UNITED STATES PATENT AND TRADEMARK OFFICE

APPLICATION NO.	FILING DATE	FIRST NAMED INVENTOR	ATTORNEY DOCKET NO.	CONFIRMATION NO.
10/602,610	06/25/2003	Anthony Pidcock	84689 3006 KAW	2474

Office Action Summary

DETAILED ACTION

5. Claims 1-4 and 12 are rejected under 35 U.S.C. 102(b) as being anticipated by **Stroem et al.** (US 4,549,847).

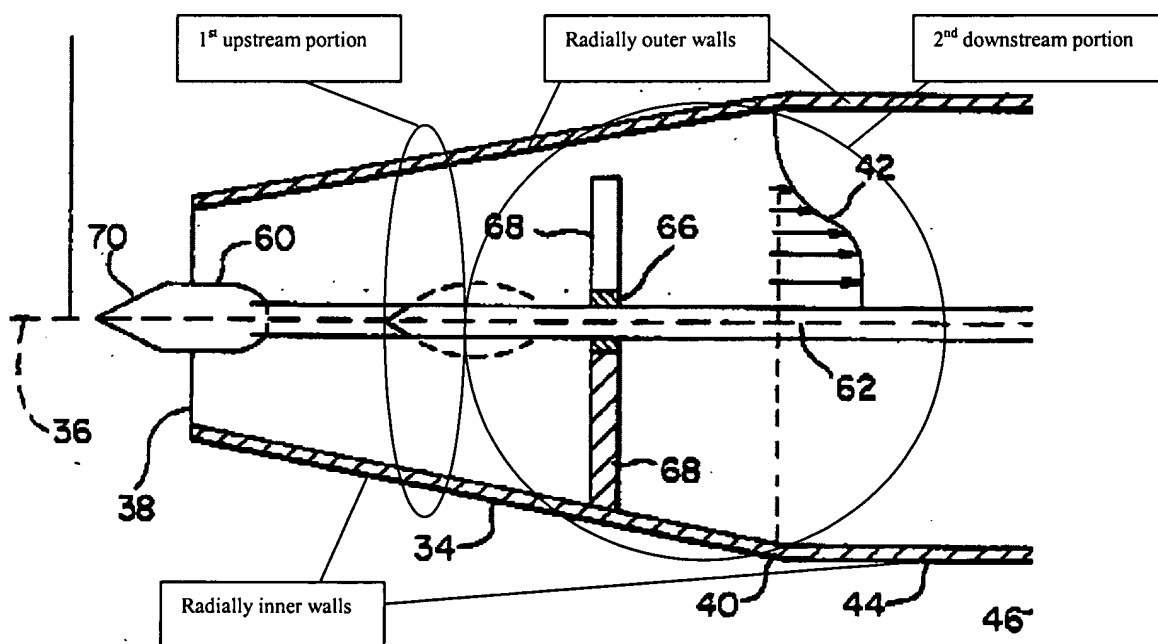
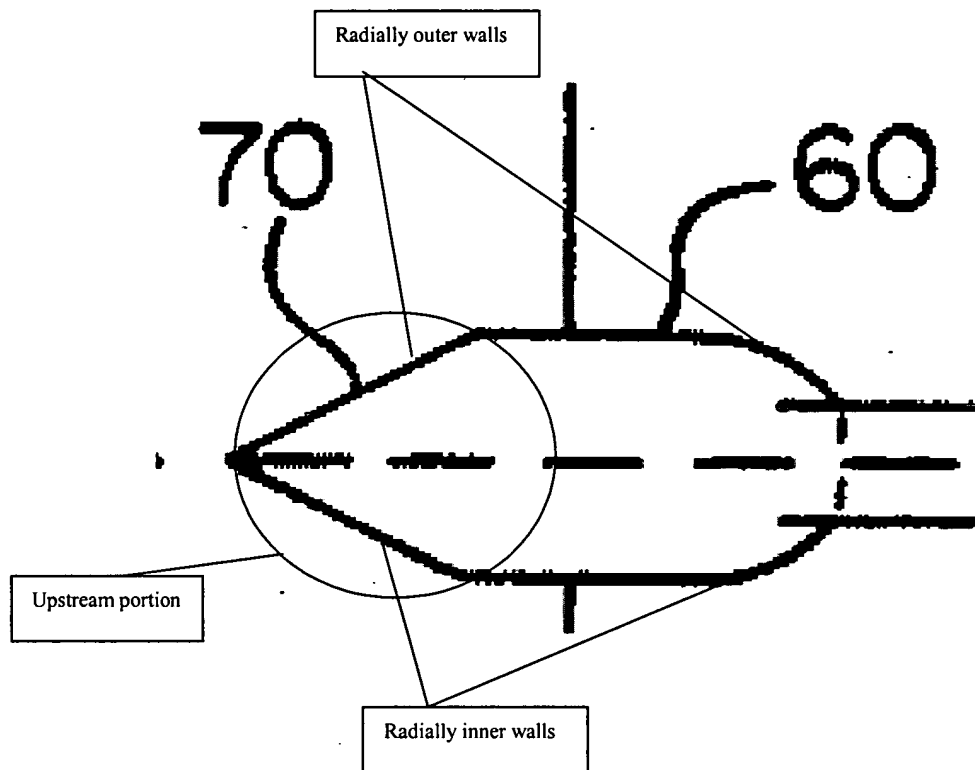
With respect to claims 1 and 12, **Stroem** teaches a gas turbine engine comprising: a diffuser 16 located between a compressor 10 and a combustor 22, the diffuser being generally annular, including radially inner and radially outer walls and a generally cylindrical midline 36 defined between the walls, wherein the diffuser is shaped to include a first upstream portion in which air flowing through the diffuser is directed away from the midline and a second downstream portion in which air flowing through the diffuser is directed at least partially towards the midline of the diffuser. See **Figure 1** above and cl. 2 ll. 43-47, cl. 4 ll. 11 to cl. 5 ll. 2.

With respect to claim 2, **Stroem** teaches that the diffuser includes a generally annular central member 60 located between the radially inner and radially outer walls, airflow through the diffuser being forced to separate and pass around the central member. See **Figure 1** above.

With respect to claim 3, **Stroem** teaches that the central member includes an upstream portion which includes radially outer and radially inner walls, each diverging away from the midline 36 of the diffuser in the downstream direction, causing air flowing around the upstream portion or the central member to be directed away from the midline of the diffuser. See **Figure 1** above.

With respect to claim 4, **Stroem** teaches that the walls are angled at between 20 to 90 degrees. Measurement by a protractor of the angle of the walls of the diffuser and central member of Figure 1 resulted in angles within the claimed range of 20-90 degrees. See **Figure 1** above.
